M12 Motorway

Amendment Report

October 2020

Figure 2-1 Key features of the amended project

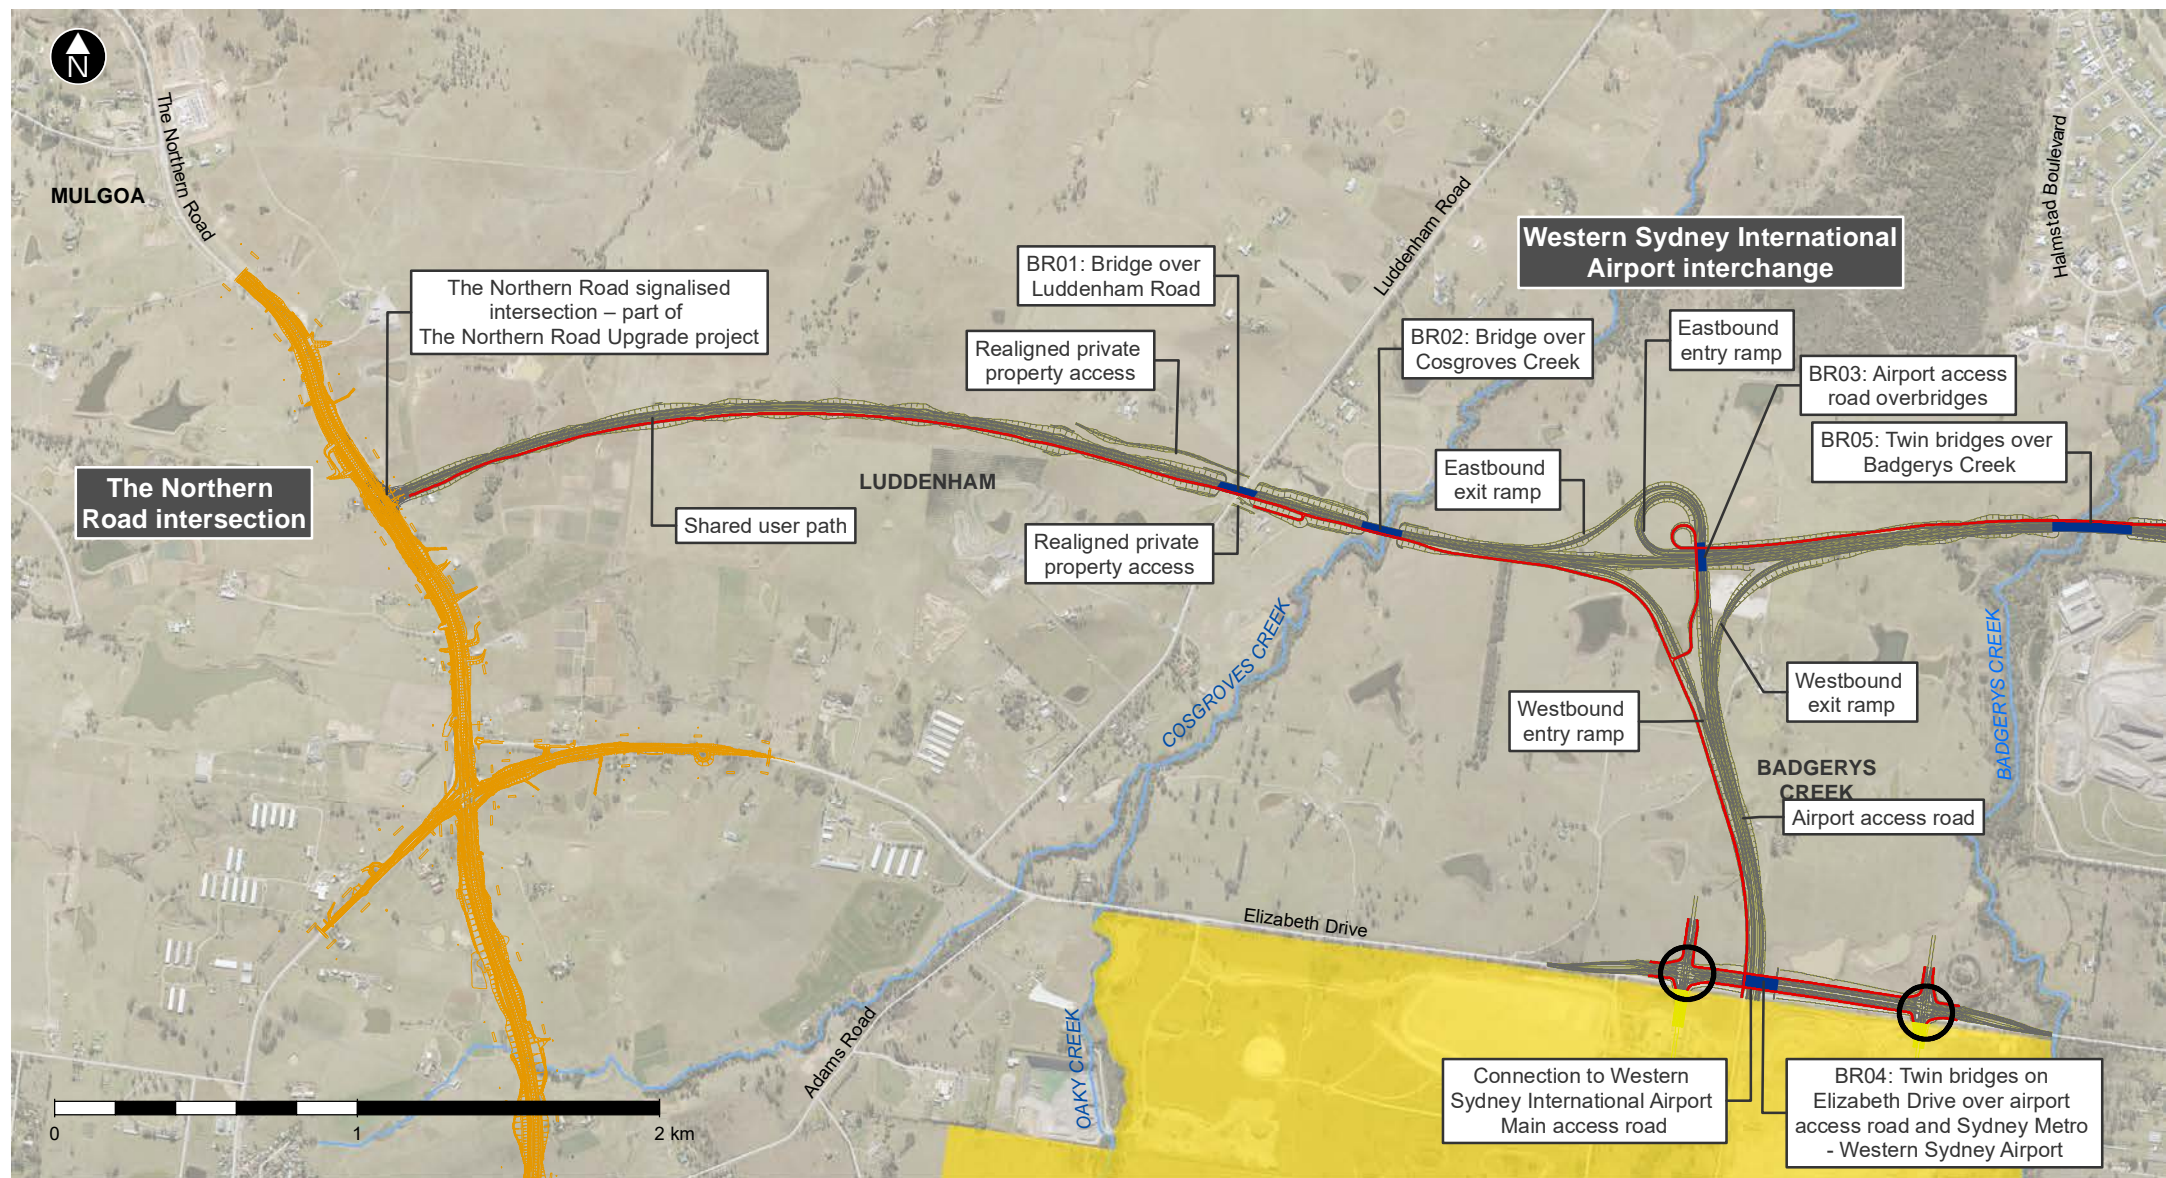
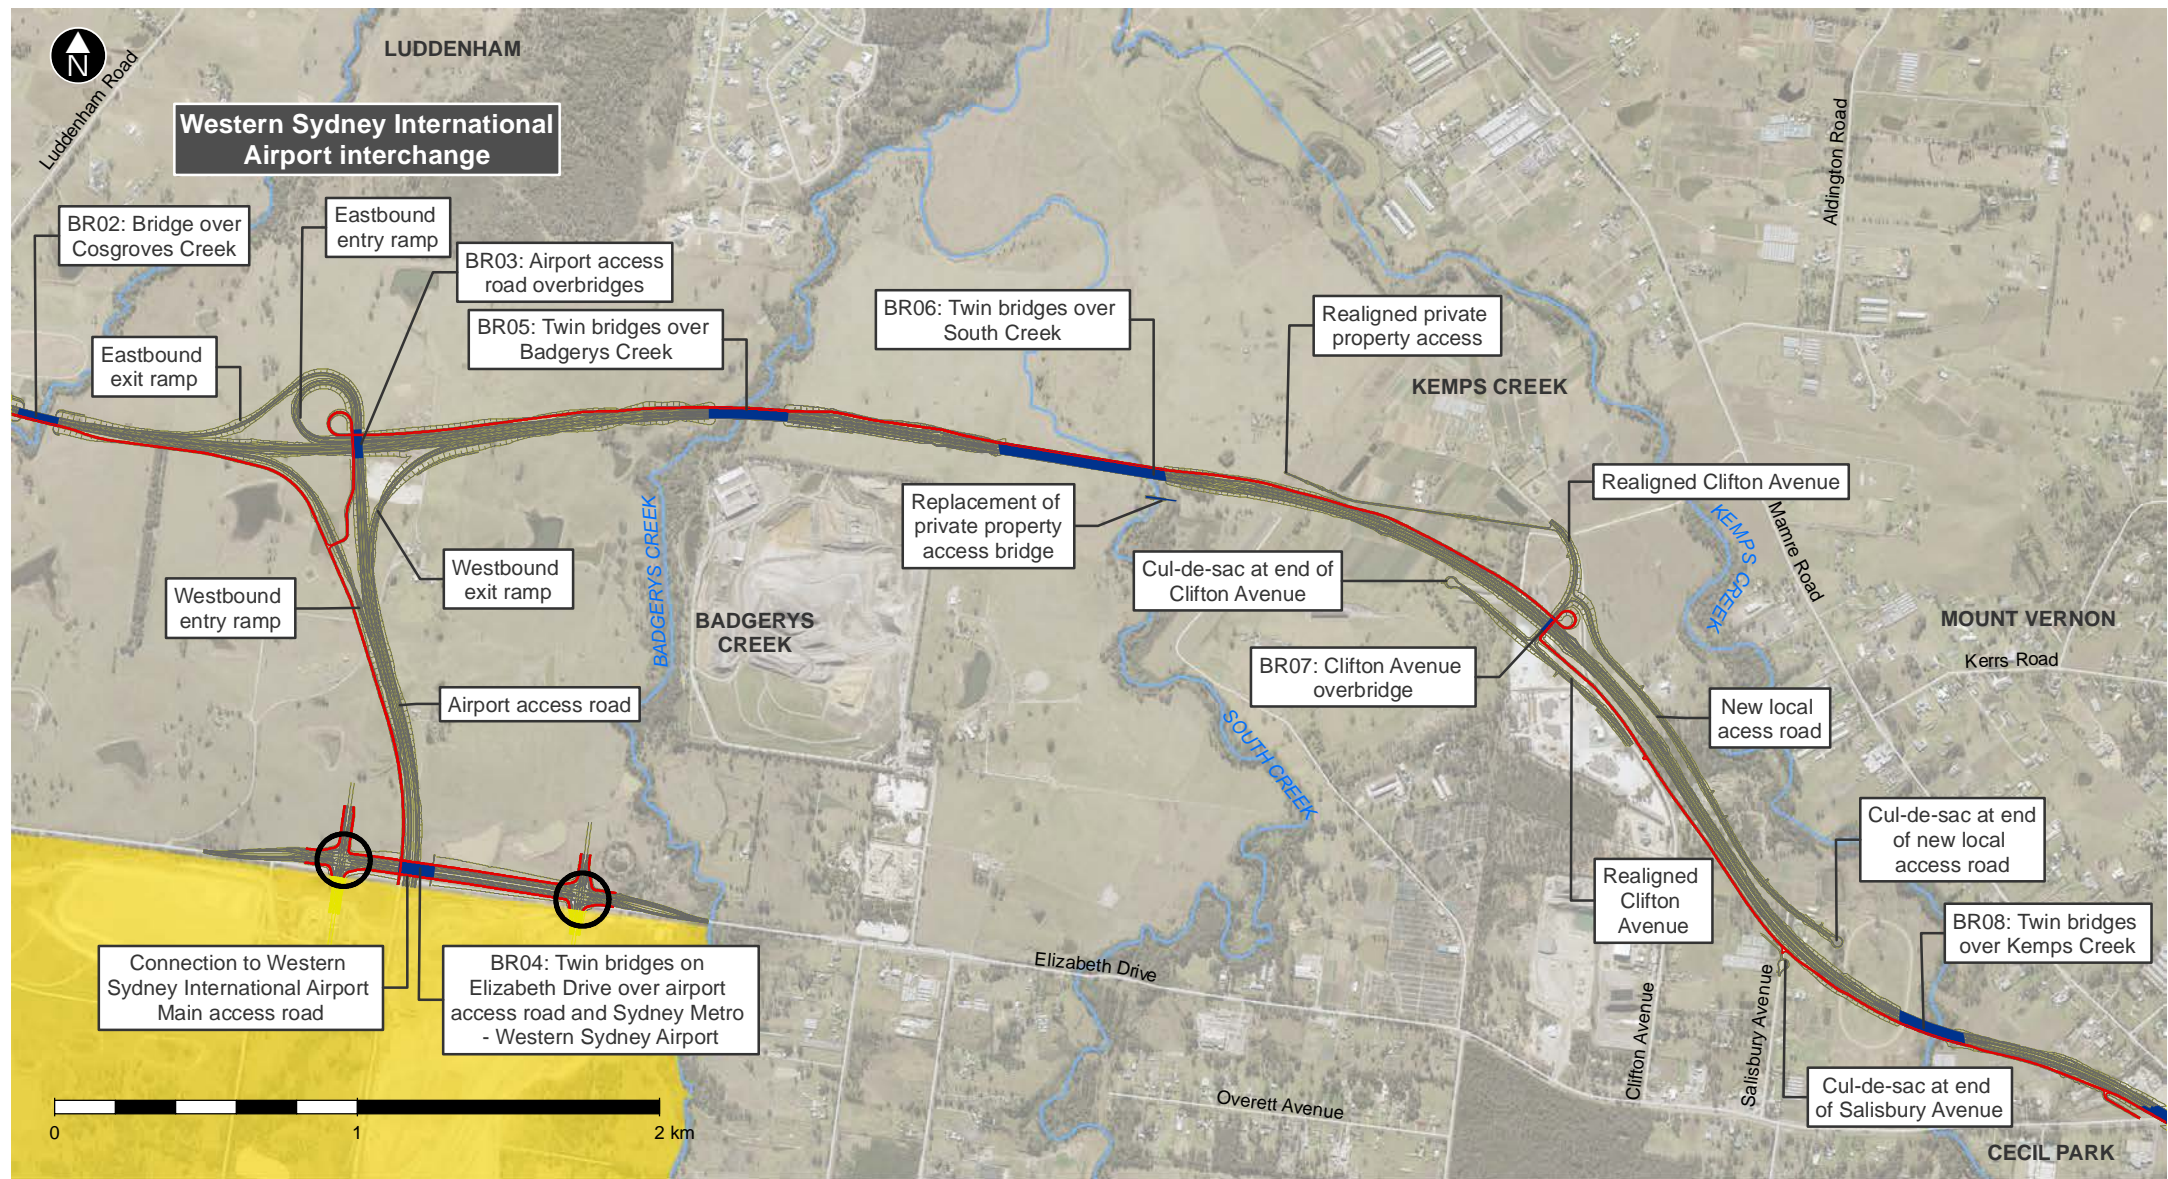
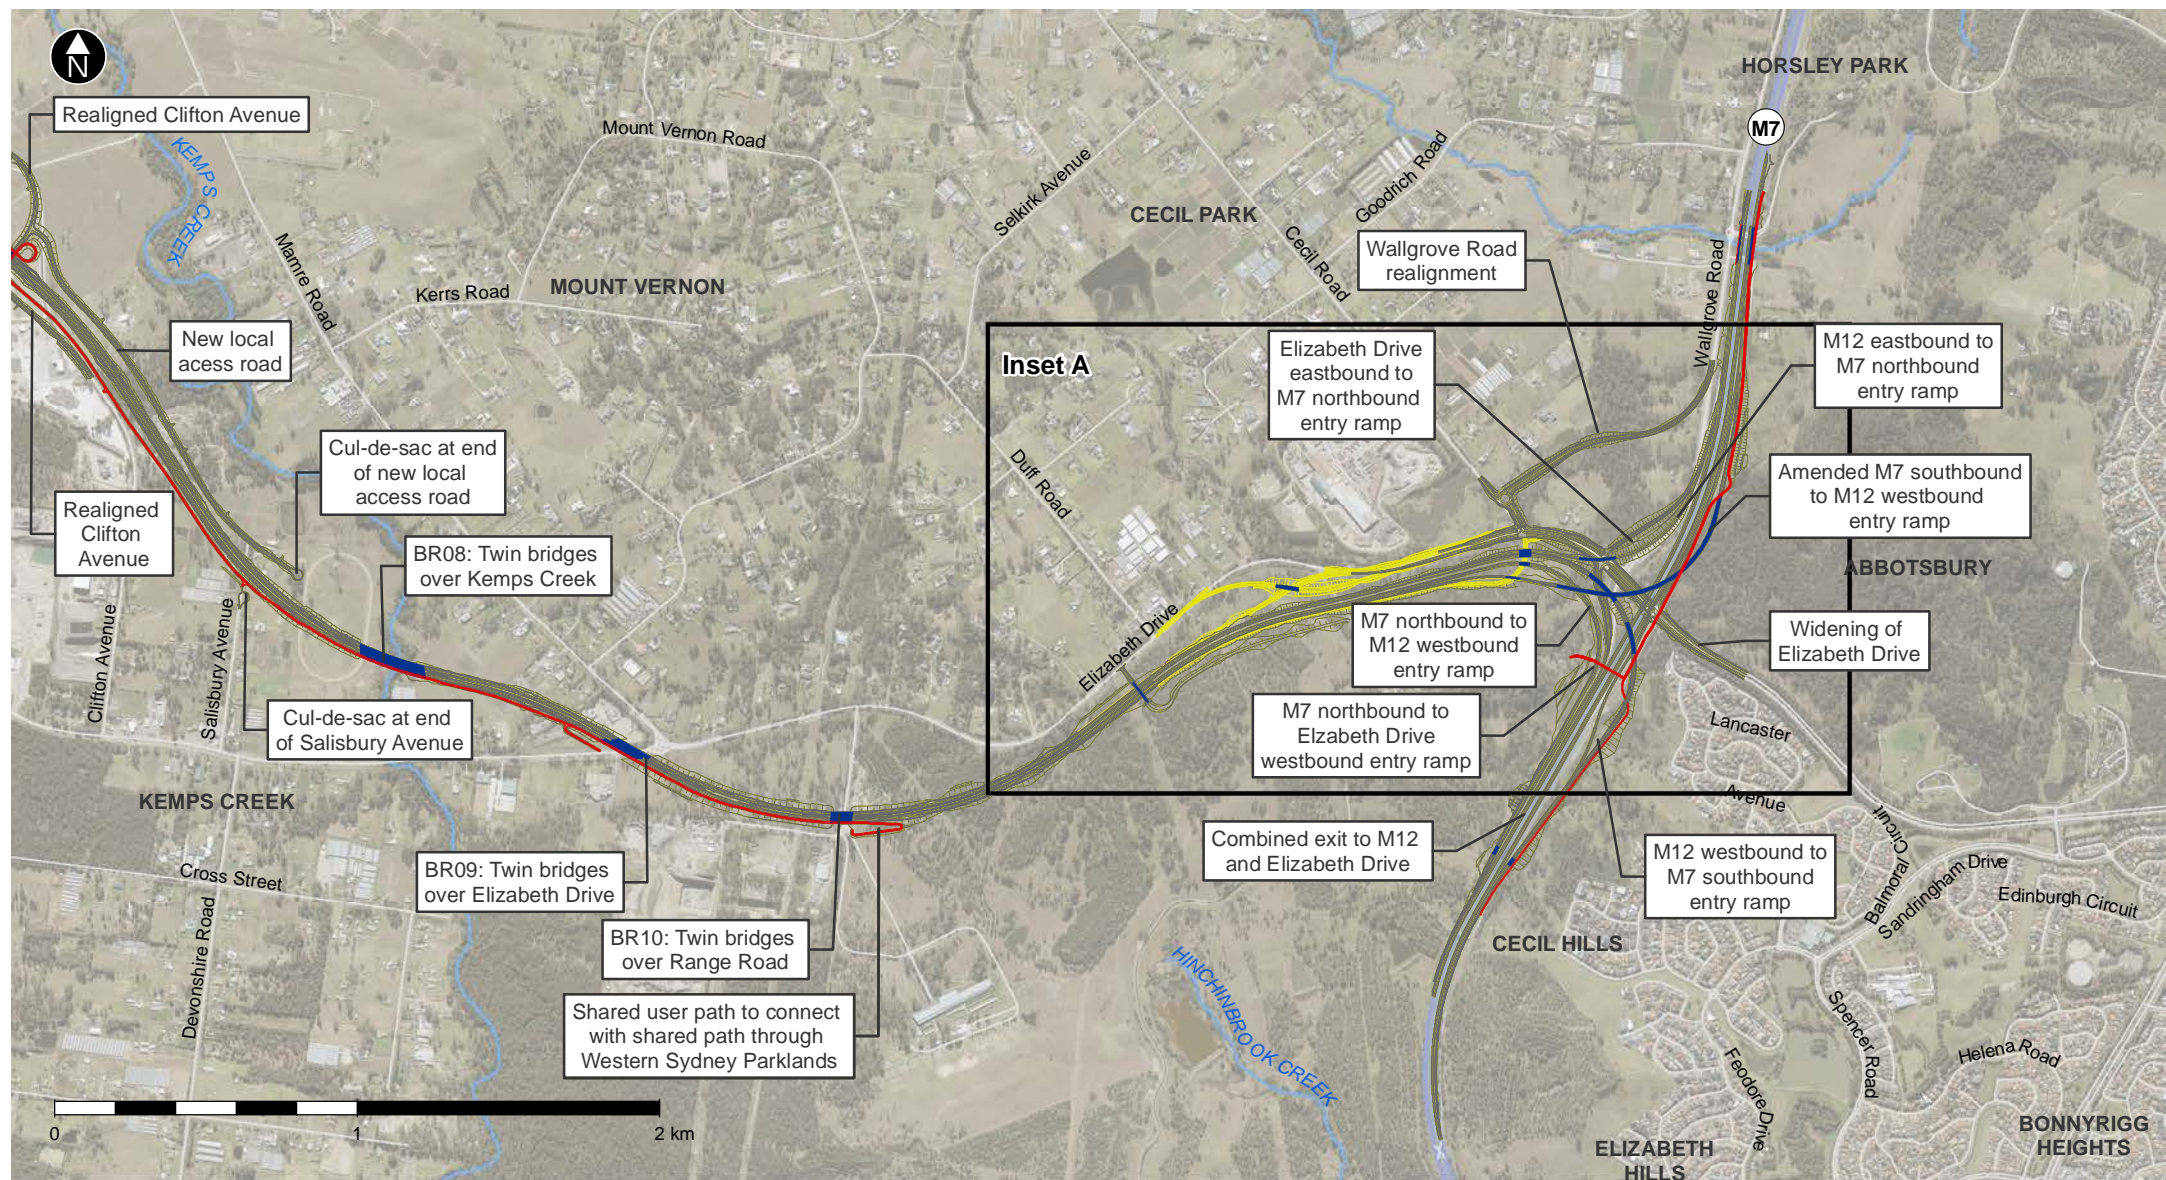
This section of the amended project is shown in **Figure 2-1**, with the Elizabeth Drive connection associated with option 2 shown in a different colour and detailed in inset A.

An overview of the key features of the amended project is provided in **Figure 2-1**. Additional figures presented throughout Chapter 3 show the changes from the project as described in the EIS.
